CODAN

DGAC HF Voice/RTTY system—failure of receiver multicoupler

Figure 1: Positioning of the RF clamp assembly

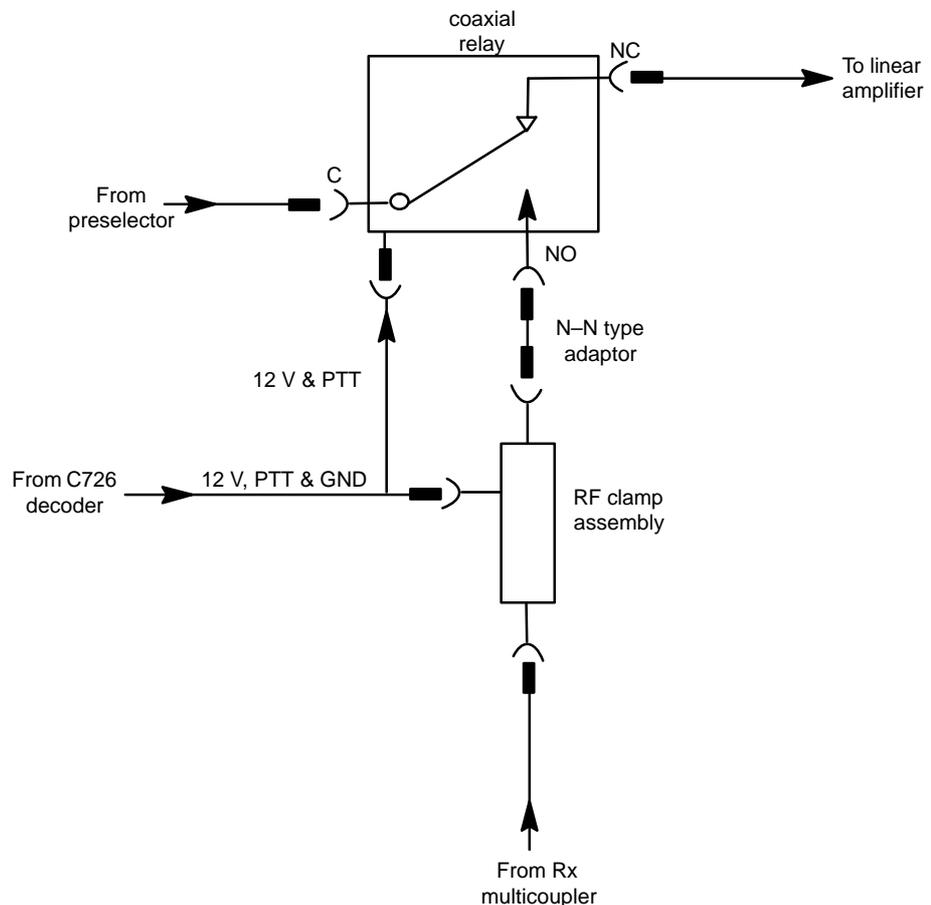
To control the magnitude of transient RF energy at the connector of the coaxial relay:

- Insert an RF clamp assembly (part number 08–05656–001) in the coaxial line at the coaxial relay of each transceiver system (see Figure 1).

The RF clamp limits the magnitude of transient RF energy to approximately 4 V, which will prevent any damage to the receiver multicoupler.

The units have been fitted with coaxial N–N type adaptors so the RF clamp can be directly connected to the coaxial relay. The 12 V DC and 0 V (Gnd) supply lines are provided to the RF clamp by using the original cable from the C726 decoder to the coaxial relay. The RF clamp is provided with a 7–way female connector. The wiring of the connector to the RF clamp is such that once it is installed, the RF clamp must be connected to supply 12 V DC to the coaxial relay. This ensures that the relay cannot operate unless the clamp is connected in circuit, which prevents high levels of RF energy from reaching the multicoupler.

- Sleeve the blue core and leave unterminated.
- Replace the front panel of the C726 decoder.
- Fit the RF clamp to the NO port (Rx) of the coaxial relay.
Orientate the RF clamp as specified on the label.

- Connect the coaxial cable from the receiver multicoupler to the opposite end of the RF clamp.
- Rotate the RF clamp such that the 7-way female connector is positioned to the front of the relay.

- Connect the 7-way male connector on the cable from the C726 decoder to the RF clamp.
- Pass the free cable end through the P clip on the relay and retighten the securing nut.
